Traces of moisture on the computer (spare-parts n. 531722) due to silicone bead leaks

Model EDG 6600.1M

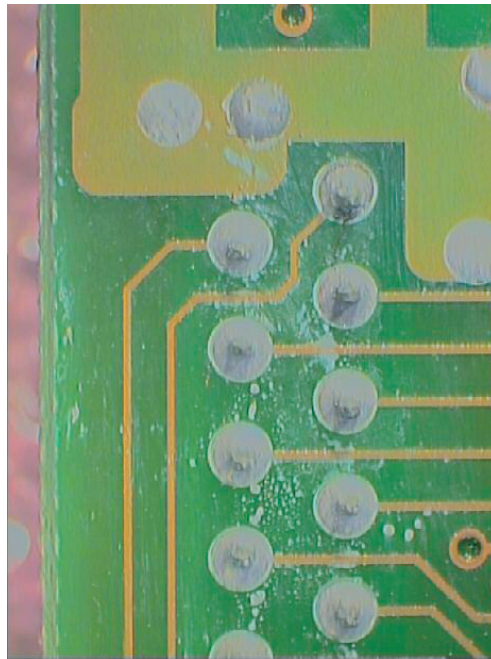
Leaking silicone beads may allow steam to escape and cover the circuit board of the computer in the vicinity of the flat cable connector. This may result in error message F 10.

Marks will become visible on the circuit board if this occurs over a longer period (see photo).

Seal the joint more thoroughly with silicone.
